From: Bob Murchison <bob.murchison@me.com>
Sent: Tuesday, September 24, 2024 3:36 PM
To: 'Bouley, Steven'; 'Dillon, Peter'
Cc: Jeanne Guthrie
Subject: FW: Response to BOH Comments on Brush Hill Homes
Attachments: Brush Hill Homes deficiency letter.pdf; Brush Hill Floor Plan Eight Homes September 2024.pdf; F25889 BOH Plan Set.pdf

From: Bob Murchison <bob.murchison@me.com>
Sent: Tuesday, September 24, 2024 3:34 PM
To: 'Mark Oram' <moram@sherbornma.org>; 'Jessica Edwards' <jedwards@sherbornma.org>
Cc: 'Jean Greco' <jean.greco@sherbornma.org>; 'Jeremy Marsette' <jmarsette@sherbornma.org>; 'Kevin Riopelle' <KRIopelle@dgtassociates.com>; 'Bert Corey' <bcorey@dgtassociates.com>; 'DL - Health' <health@sherbornma.org>; 'Paul Haverty' <paul@bbhslaw.net>
Subject: Response to BOH Comments on Brush Hill Homes

In addition to the updated Title V Application plan submitted yesterday (also attached here for convenience), I want to provide a detailed responses to your comments made in a letter on August 7th. Apologies for the delayed response, but your request for additional soil testing took some time.

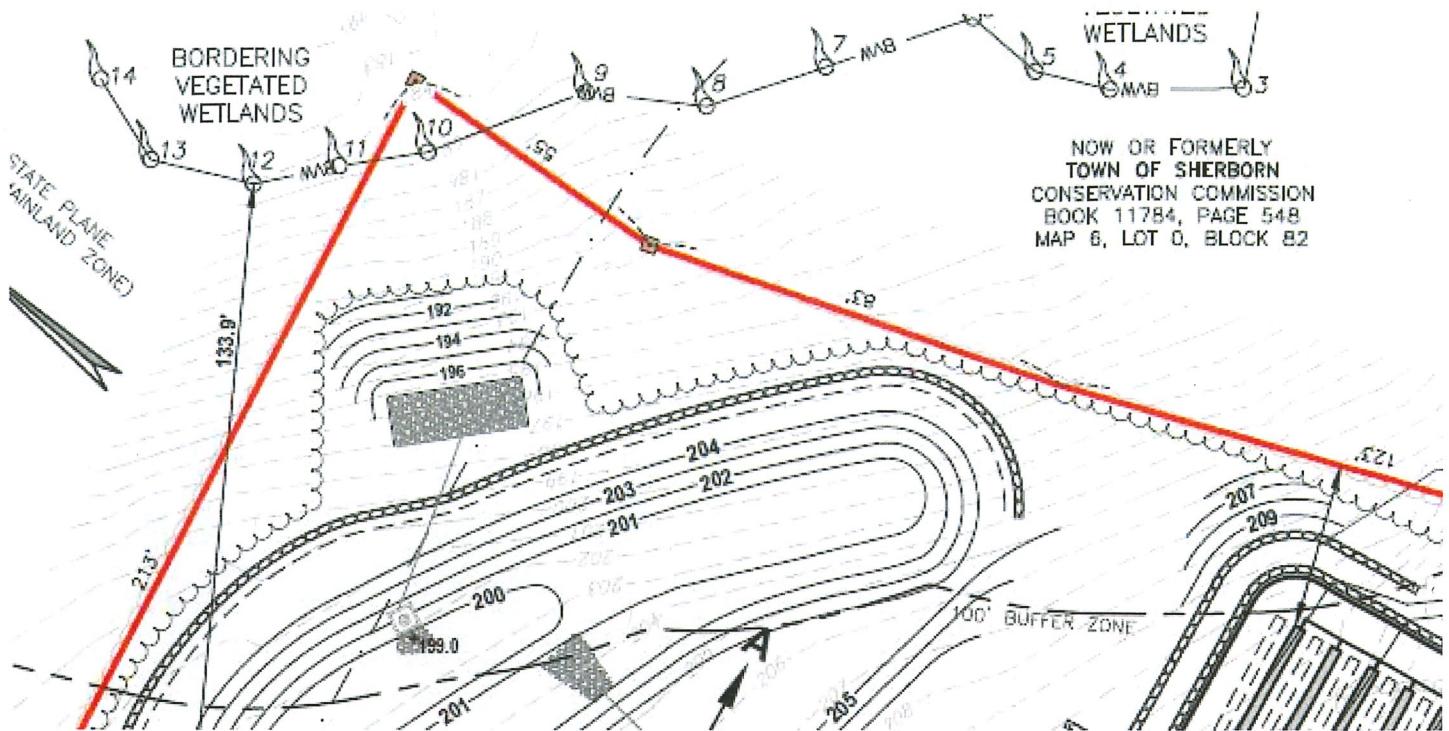
1. The buffer line on the northwest portion of the plot plan on Sheet 1 of 4 does not define the buffer zone.

The wetland line and 100' buffer zone are both shown on page 1 of the plan. See screenshot below.
